UNITED STATES PATENT AND TRADEMARK OFFICE

APPLICATION NO.	FILING DATE	FIRST NAMED INVENTOR	ATTORNEY DOCKET NO.	CONFIRMATION NO.
10/523,950	10/19/2005	Ian James Prismall	ARD120USA	9425
24339	7590	11/15/2007		
JOEL D. SKINNER, JR. SKINNER AND ASSOCIATES 212 COMMERCIAL ST. HUDSON, WI 54016			EXAMINER AMIRI, NAHID	
			ART UNIT 3679	PAPER NUMBER
			MAIL DATE 11/15/2007	DELIVERY MODE PAPER

Office Action Summary	Application No. 10/523,950	Applicant(s) PRISMALL, IAN JAMES	
	Examiner Nahid Amiri	Art Unit 3679

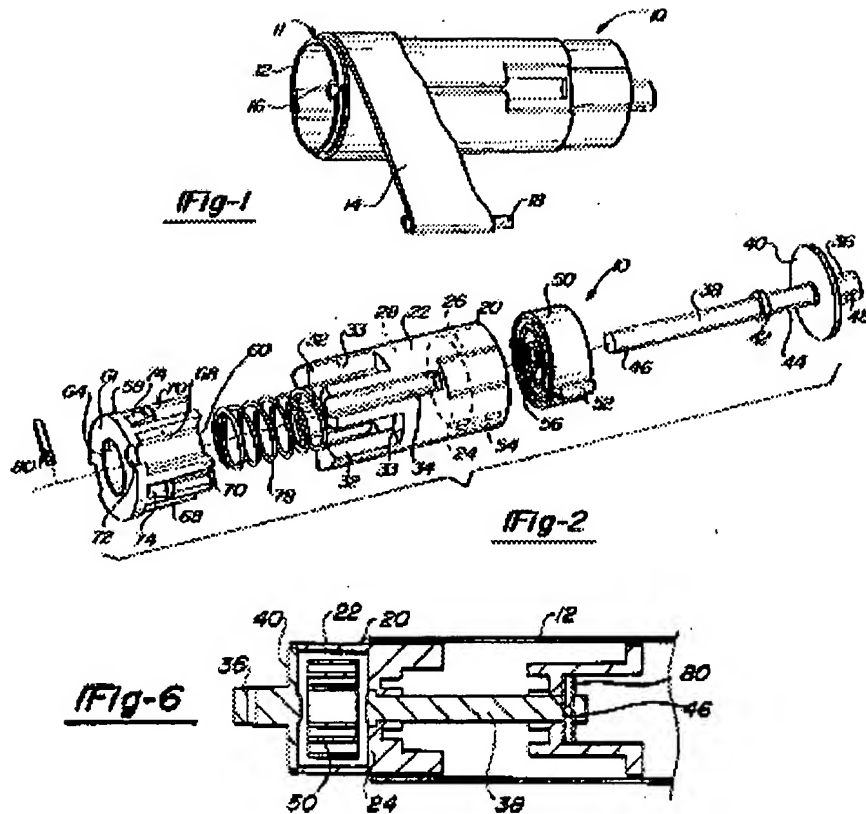
Claims 1-8 and 12 are rejected under 35 U.S.C. 102(b) as being anticipated by US Patent No. 5,934,354 Price et al.

With respect to claims 1-8 and 12, Price et al. disclose a retractable barrier system (10, Figs. 1-2) comprising a support member (20), a spool (50) supported for rotation by the support member (20), a spring (78) arranged to provide a biasing load to the spool (50), and a skirt (58) the spring (78) being located beneath the skirt (58) and the skirt (58) being arranged to deflect water away from the spring (78) which would otherwise impinge on the spring (78); wherein the spring (78) is located beneath the spool (50); wherein the skirt (20) is carried by the spool (50); having all the components of the barrier system such as the spool (50) and the skirt (58) are interconnected with each other that constitutes unitary with one another; further having a cover (constituted by a wall 40 of axel 36), a closed compartment within the spring (78) is housed; wherein (Fig. 6) suggests that the cover (40) is secured to the skirt (58) by a least one snap-fit coupling; further having a fixed spindle (38) supported by the support member (20) and upon which the spool (50) is mounted for rotation; wherein the spring (78) includes a first end part anchored to the support member (20) and a second end part is capable of driving the spool (50).
